R99CL

RECALL R99CL
OPTION FOR THREE BATTERIES
CABLE ROUTING MODIFICATION

**SUBJECT: RECALL R99CL ROUTING OF BATTERY CABLES ON
CONVENTIONAL BUSES EQUIPPED WITH THREE BATTERIES**

Figure 1

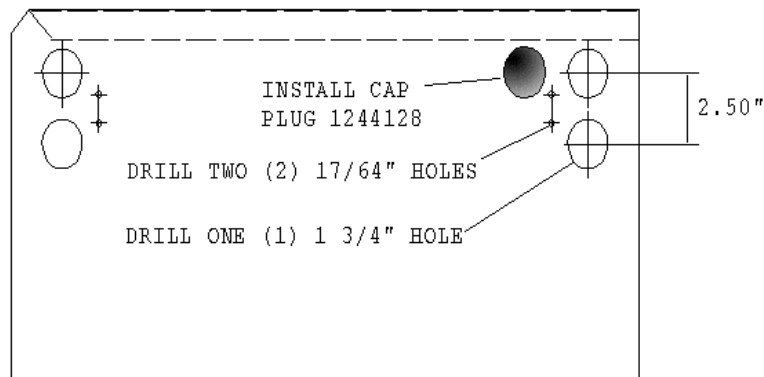
The defect involves the routing of the battery cables on the subject buses. The battery cables may not have been routed properly on buses equipped with optional three batteries. Improper routing of the battery cables could place the positive cable immediately behind the battery hold down clamp. When batteries are pushed back into the battery compartment the positive cable may be chafed or pinched causing a short to ground in the positive cable.

6. Drill a 1 3/4" diameter hole directly below rearmost battery cable hole. See Figure 1. Install new neoprene grommet over cable and route positive cable through new hole. Install new neoprene grommet into hole to protect cable.

7. Remove rubber grommet from hole directly behind battery hold down. Install cap plug (#1244128) as indicated by shaded area in Figure 1 on page 1.
8. Remove rubber grommet in rearmost upper hole. Install new neoprene grommet (#0421792). Route negative battery cable through upper hole.

Figure 2

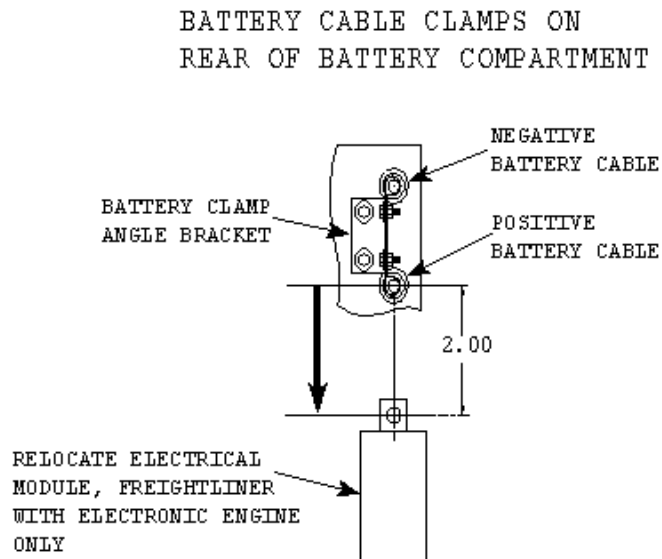
10. Reattach battery cable clamps. Using the clamp angle bracket as a guide, mark and drill the two (2) 17/64" holes for the battery cable clamp. Reinstall bolts in the battery cable clamp angle bracket. *Do not tighten at this time.*

Figure 3

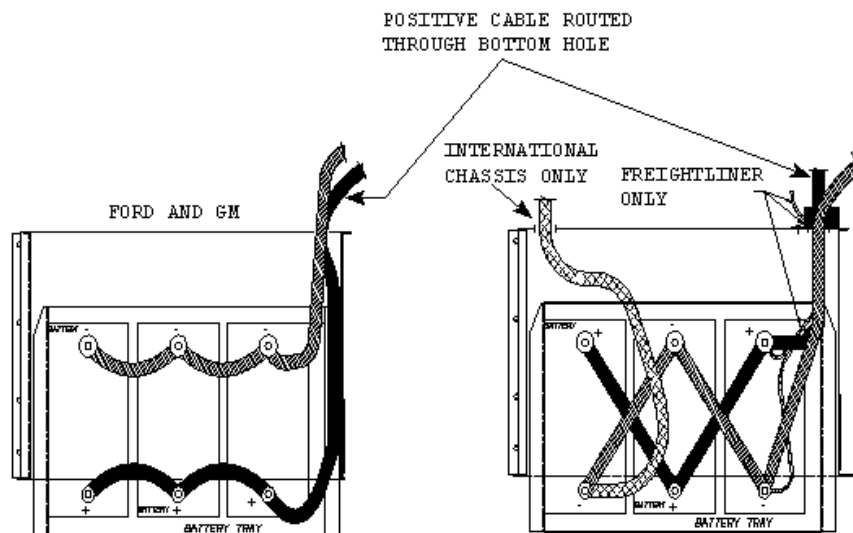
11. Route positive cable through bottom rearmost hole in the battery compartment and reconnect to positive battery terminal.
12. Route negative cable through the top rearmost hole in the battery compartment and reconnect to negative battery terminal.

13. For electronic engines the computer harness is not shown. However, computer harness must be kept as low as possible to prevent damage to cables when sliding battery tray out of battery compartment. Tie to the battery cables with nylon tie straps if necessary.
14. Tighten the two (2) bolts in the battery cable clamp angle bracket on back of battery compartment. Tighten clamps around battery cables.
15. Carefully slide battery tray into compartment. Check for binding or pinching of cables. Adjust as needed.
